Project: 26 Agamemnon Road, NW6 1DY – loft conversion and associated works
Client: Nicolas Trebino
Date: 19th January 2017

Reference 2016/7018 - Loft conversion involving the installation of a rear dormer extension, 3 x front rooflights and 2 x rear rooflights.

Image 1. Aerial view of the block bounded by Agamemnon Road, Gondar Gardens and Hillfield Road

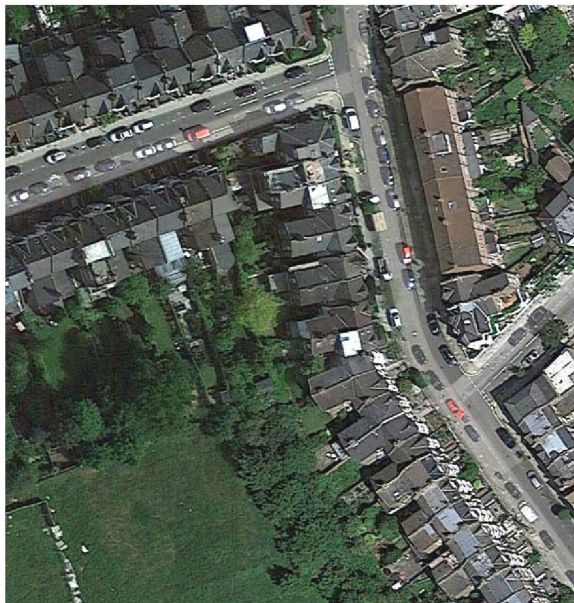
We believe that the specific position and surroundings of this property should be afforded particular consideration. I have walked around the block which contains the property in an attempt to take photos back to the site, however I found no clear sightlines of the rear pitch of the main roof from street level, all are obscured by buildings and/or trees (see Images 1-4). The disused reservoir site at the centre of the block is not accessible to the public and is surrounded by mature trees which provide significant screening. My opinion is that the views to the roof of the proposed dormer would be limited to those from the upper floors of a handful of properties along Gondar Gardens, directly to the north (see Image 5), and the gardens of the immediate neighbour, No. 28 and the lower flat at No. 26. The pattern of rear outriggers would prevent views to the dormer from the other gardens. It would not be visible from more distant views.
